# Access Compliance Report

## Public Rights-of-Way

### (Curb Ramps)

Intersection ID: 49348	Main Street: HONEY_FIG_RD	Cross Street: FIRESPIKE_RD	Location: NE
ADA ID: FA83277EE6F0	Ramp Type: Perp	Initial Pass/Fail: Pass	Overall Compliance: No
		Severity Score: 0

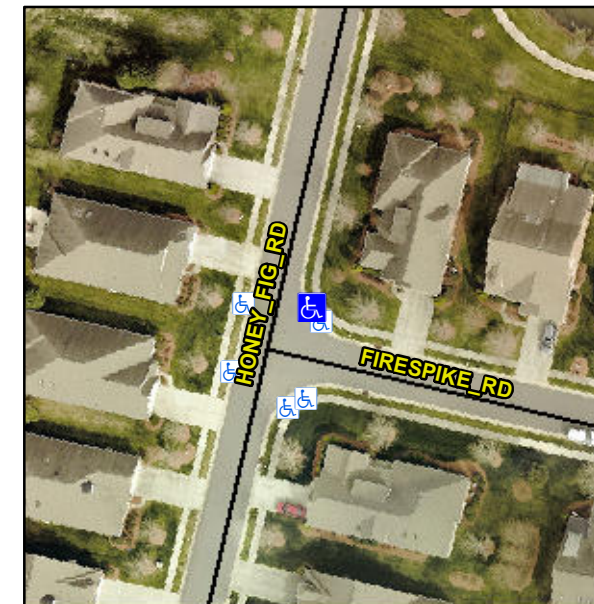
**Not Found, R304.2.2-Perp, R304.3.2-Para**

Compliance	Description	Data	Compliance	Description	Data
N/A	Ramp Length (in)	45.0	Yes	Ramp Slope (%)	7.0
Yes	Ramp Width (in)	48.0	Yes	Ramp XSlope (%)	1.5
N/A	Flare Type LT	Sloped	N/A	Flare Type RT	N/A
N/A	Flare Slope LT (%)	5.9	N/A	Flare Slope RT (%)	3.5
N/A	Flare Traversable LT?	No	N/A	Flare Traversable RT?	No
Yes	Landing Length (in)	48.0	Yes	DWS Provided?	Yes
Yes	Landing Width (in)	48.0	Yes	DWS Contrast?	Yes
No	Landing Slope (%)	3.4	Yes	DWS Length (in)	25.5
Yes	Landing X Slope (%)	1.0	Yes	DWS Full Width?	Yes
N/A	Landing Curb? (Y/N)	No	Yes	DWS Offset (in)	1.5
N/A	Shared Landing?	No			
Yes	Gutter Ponding?	No	Yes	Gutter Slope (%)	3.4
Yes	Gutter Lip Ht (in)	0.0	Yes	Gutter X Slope (%)	0.8
N/A	Painted X Walk1?	No	N/A	Painted X Walk2?	N/A
	X Walk 1 Direction	To NW		X Walk 2 Direction	N/A
N/A	X Walk 1 Width (in)	N/A	N/A	X Walk 2 Width (in)	N/A
	X Walk 1 Slope (%)	1.2		X Walk 2 Slope (%)	N/A
	X Walk 1 X Slope (%)	0.9		X Walk 2 X Slope (%)	N/A

**Remove & Replace Entire Ramp.**
